Department of Energy
Richland Operations Office**memorandum**DATE: **AUG 11, 2003**
REPLY TO: WEC:WFH 03-WEC-036
ATTN OF:SUBJECT: DESIGN OVERSIGHT REPORT – “LOW ACTIVITY WASTE (LAW) MELTER
SUPPORT SYSTEM CAPACITIES,” D-03-DESIGN-002TO: William J. Taylor, Assistant Manager
for Waste Treatment and
Immobilization Plant

Waste Treatment Plant
LAW Melter
Support System Capacities

D-03-DESIGN-002

Figure i

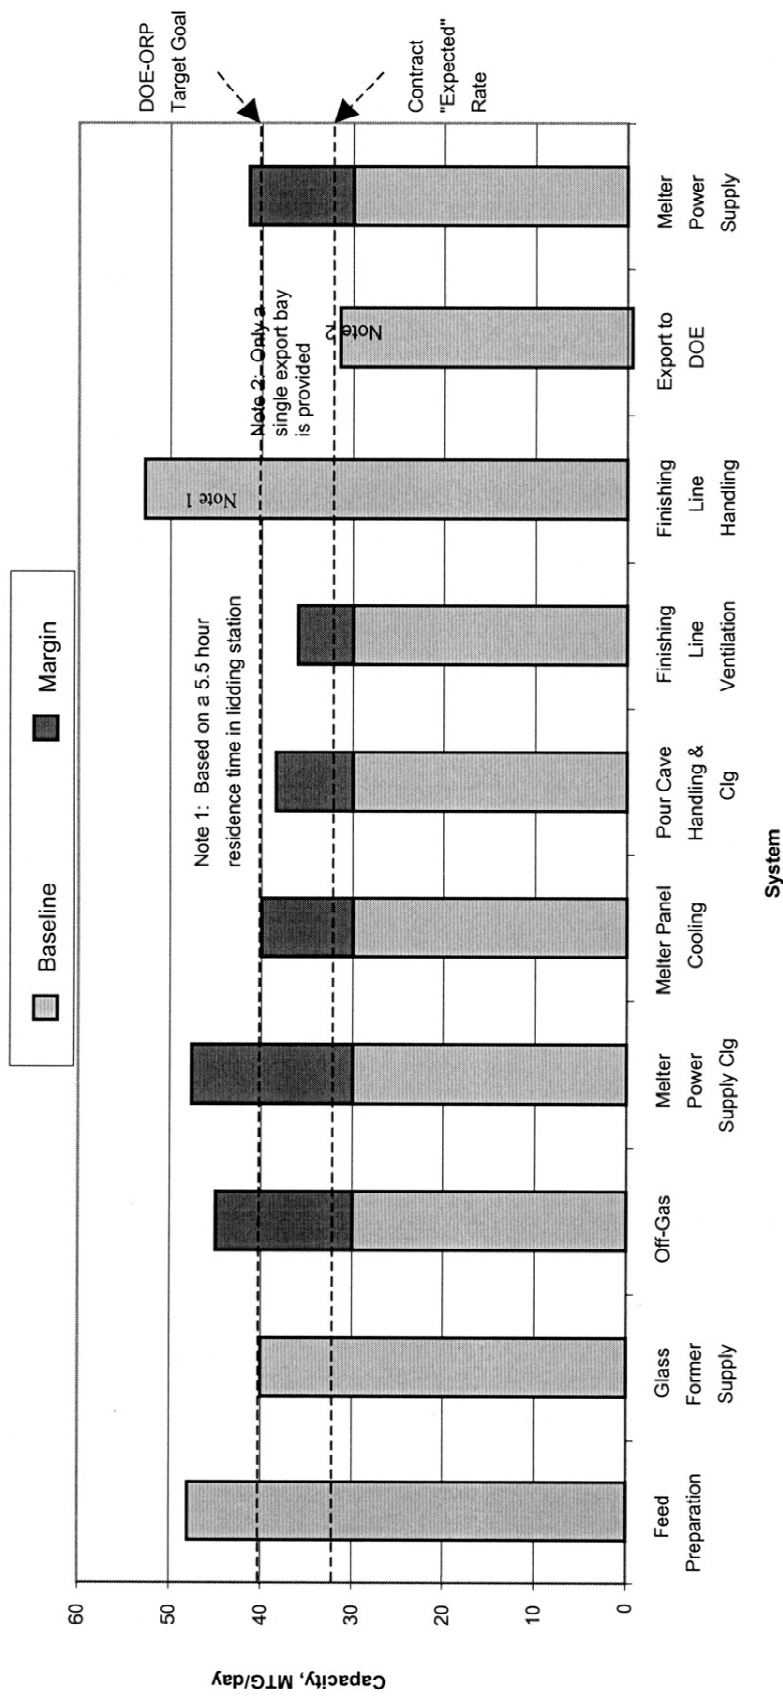
The results of the estimate of the impact of each area of the LAW facility reviewed on the peak glass production rate of the facility are summarized in Figure i (Figure 1 in the report). This figure shows the peak production rate that could be supported by the identified area or system independent of the rest of the LAW facility capabilities. This figure shows that the most limiting area of the facility is the time that is required to transfer canisters from the facility airlock to DOE for burial. This limits production to 32 MTG/day. This is acceptable to meet baseline Contract requirements, which are equivalent to a peak production rate of 24 MTG/day minimum and 32 MTG/day expected. This rate does not meet the target goal of the Contract of 36 MTG/day nor the stretch DOE-ORP target goal of 40 MTG/day. It should be noted that the plan for transfer of the canisters to DOE has not been finalized for the current design of the facility. Data from original facility analyses were used to establish the time for this evaluation. It is believed that relatively straightforward changes could be made to reduce the time required for export of canisters to DOE, and support a production rate at the DOE-ORP target goal.

Figure 1

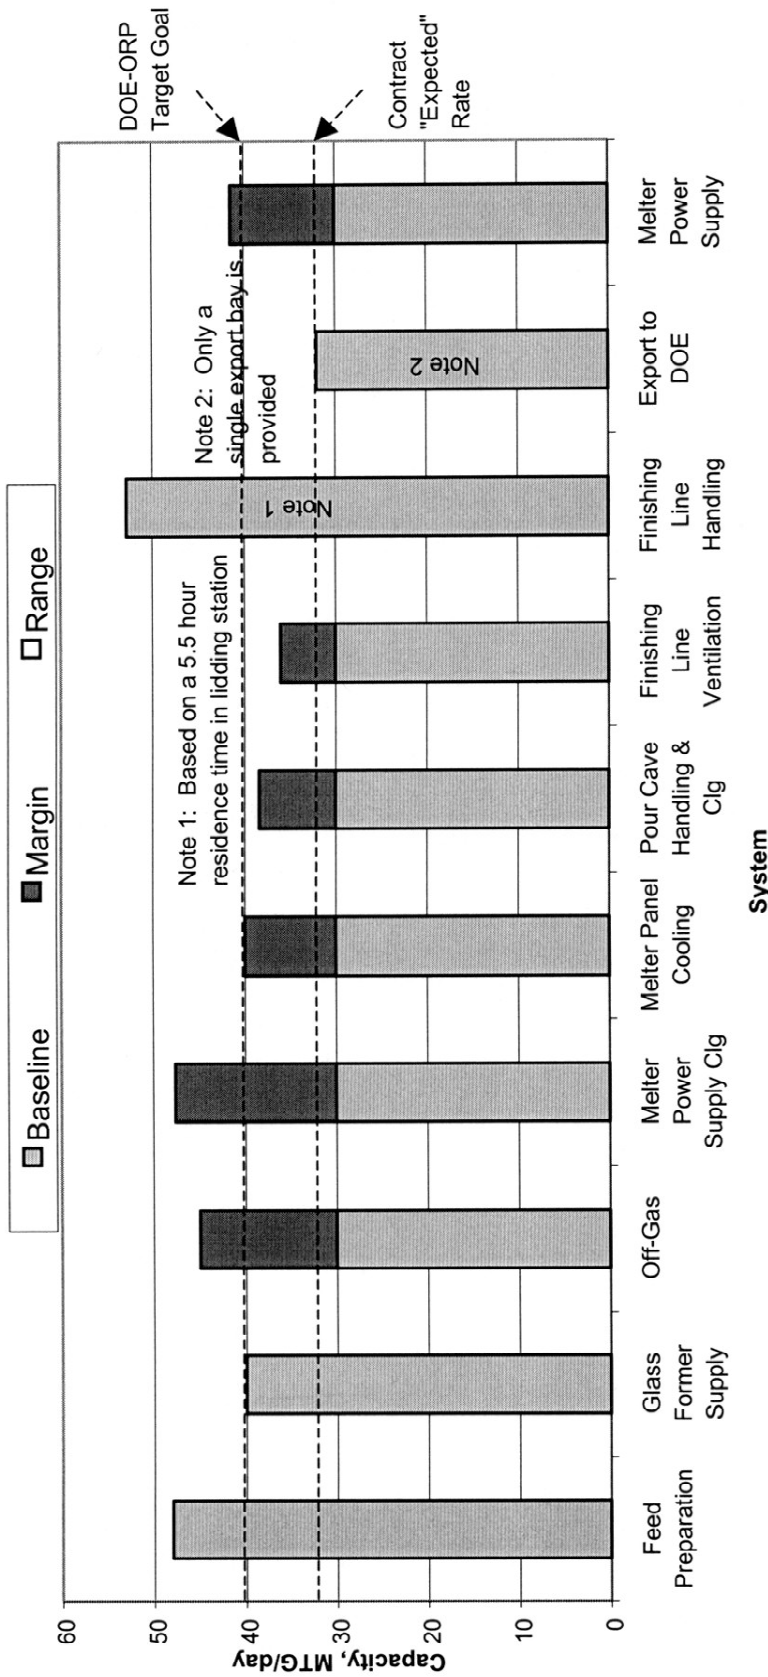
- 4.1.1 Figure 1 summarizes the results of the review of design capacities of the LAW melter and facility support systems. The bar chart shows the capability of each area reviewed in terms of the limit that area imposes on the peak glass production rate of the facility in metric tons of glass per day, independent of the balance of the LAW facility. The lighter area of each bar terminates at a glass production rate that is consistent with the baseline design capability of the area. In general, BNI is designing for a peak production rate of 15 MTG/day for each melter or 30 MTG/day for the

facility. The darker areas of Figure 1 show estimated margin in the capacities of the reviewed systems.

Review of Figure 1, when considering baseline capacity and margin, shows that the maximum achievable production rate of glass for the current design of the facility is limited to 32 MTG/day; the current peak rate at which canisters are transferred from the facility to DOE. It should be noted that this rate is based on the original facility design and that the process for delivery to DOE in the current design has not been developed. It is believed that this rate can be readily increased such that this does not limit the production rate of the facility.

- 4.1.3 The results of the evaluation show that the facility most limiting peak production rates exceed the rate that is required to meet Contract baseline production rates. At a peak production rate of 30 MTG/day a facility availability of about 0.66 is required to achieve the Contract treatment rate of 733 units of Na per year (assuming Envelope A and 14 wt% Na₂O). The current estimate of availability for the LAW facility is 0.77 assuming a 16 week bubbler lifetime. The review concluded, therefore, that there were no system constraints on operating the facility at a rate consistent with Contract requirements. Note that in some cases this oversight review concluded that the baseline design capability exceeds the baseline rate of 30 MTG/day and the Contract expected rate of 32 MTG/day (shown as a dotted line on the figure).

Figure A.1-1

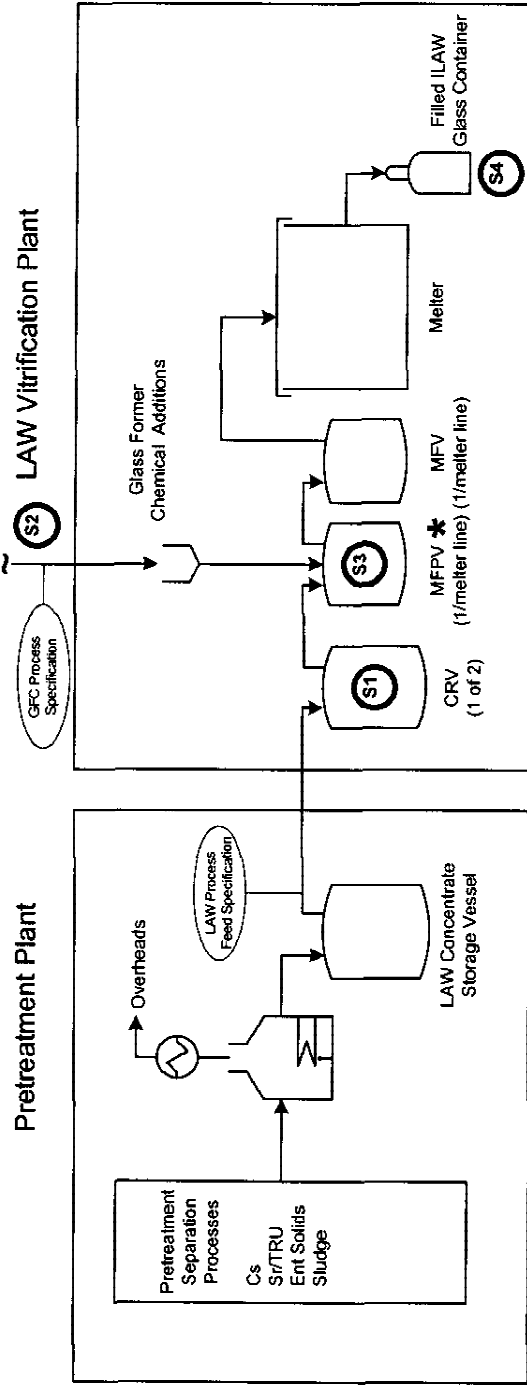
Figure A.1-1 summarizes the flow path and sampling plan for the LAW melter feed to confirm compliance of the glass waste form for burial [1, 2, 3 and 4]. This figure and the following discussion were developed from review of the references and discussions with cognizant BNI personnel.

Typical ILAW Canister Processing Sequence

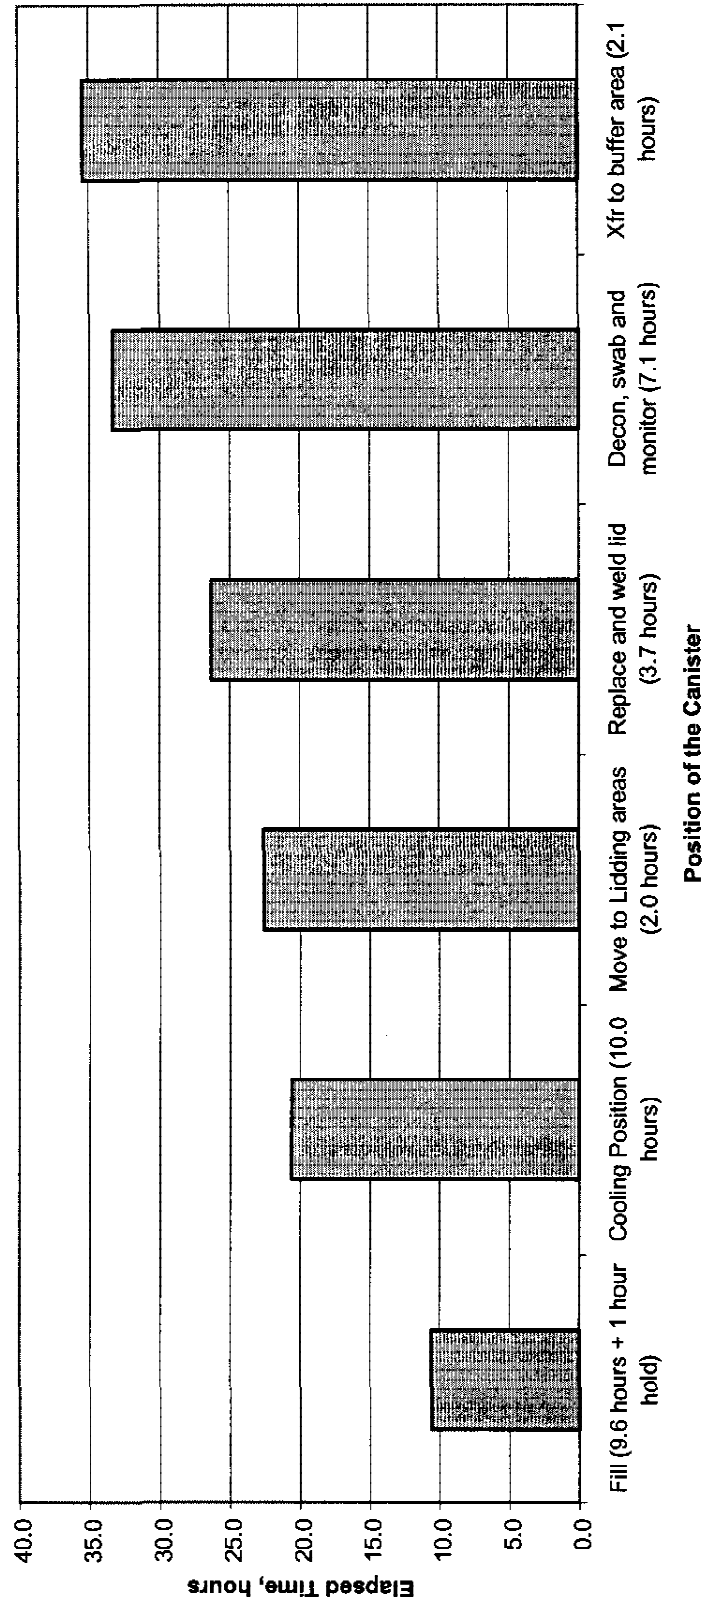
ORP Question	Additional ORP Information Concerning the Question	BNI Response
<p>provided to resolve that problem. Are the CFD and the system design calculations complete and consistent?</p> <p>7. The calculations for the cooling requirements for the pour caves are based on single line operation but include a factor of 1.33 to account for alternating use of the two lines per melter. This implies that the two lines will not be operating at full capacity. If they were it appears that the heat load would be a larger multiple of the single line (approaching 2). Has the basis for the 1.33 been evaluated for current operating assumptions?</p>	<p>Calc no. 24590-LAW-MEC-PCW-00012 (committed)</p> <p>The calculation states that the 1.33 is based on earlier CFD model results from reference 9.2 of the calculation. It is not known on what operating scenario this factor was based.</p> <p>It is understood that this calculation may no longer be explicitly relevant since these heat exchangers may no longer be used in the system. However, the heat loads should be relevant and have to be accommodated by the pour cave and transfer tunnel panels and the BOF supplied PCW.</p>	<p>modeling. The calculations are not final.</p> <p>The 1.33 factor is the total for both lines for each melter operating at full capacity. The basis is from an earlier CFD analysis that included alternating cave use for each melter. This basis is valid for the current operating assumptions. This criteria was checked to be bounding after the change in glass properties. A sketch showing the carousels and the cooling curve for the canister will be forwarded later.</p> <p>See Attachment B-1 for additional information</p>

see page A7-26 of fan sizing calculation.

Attachment B-1 -- Information supporting response to question B.7.
